**HYUNDAI**
Technical Service Bulletin

GROUP INTERIOR	NUMBER 19-BD-004H
DATE AUGUST 2019	MODEL(S) Genesis (DH)

SUBJECT: SEAT BACKBOARD CLIP REPLACEMENT

Description: This bulletin describes the procedure to replace the seat backboard clip. Some vehicles may experience the seat backboard coming loose.

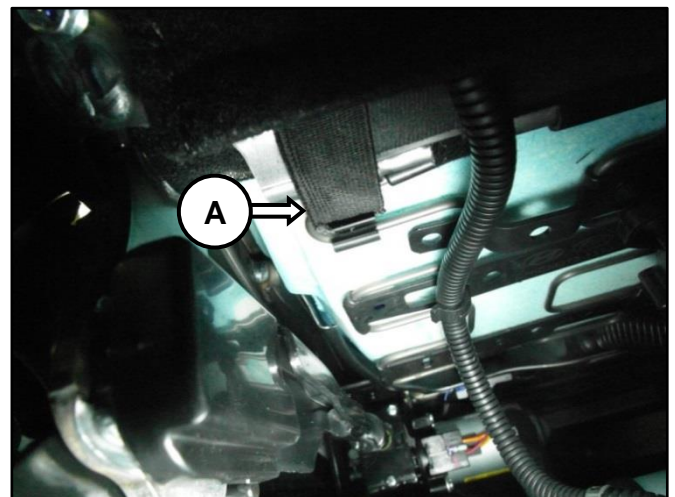
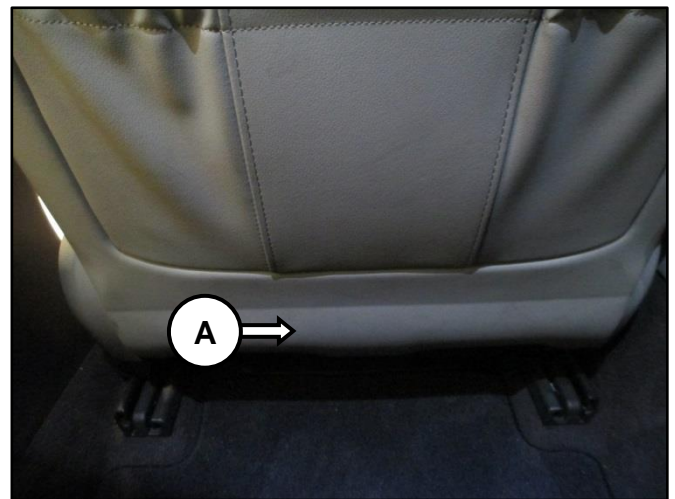
PART NAME	BEFORE	QTY
CLIP ASSEMBLY		1
	88399-B1000FFF
